South East Australia Gas Pty Ltd

ElectraNet South Australian Energy Transformation RIT-T – Project Specification Consultation Report, Market Modelling Approach & Assumptions Report and PSCR Supplementary Information Paper

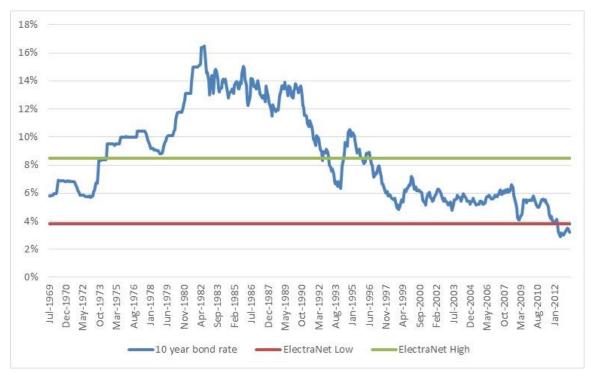
SEA Gas has compared ElectraNet's proposed range of real pre-tax WACC to the 10-year bond rate history, as shown in the chart below.

While ElectraNet's proposed WACC range covers fluctuations in the observed bond rate since the mid-1990s, it is materially below that which occurred over the two decades prior. SEA Gas therefore suggests that the high end of ElectraNet's proposed WACC range needs to be substantially increased unless some other form of protection (such as a cap on the allowable regulatory return) is to apply.
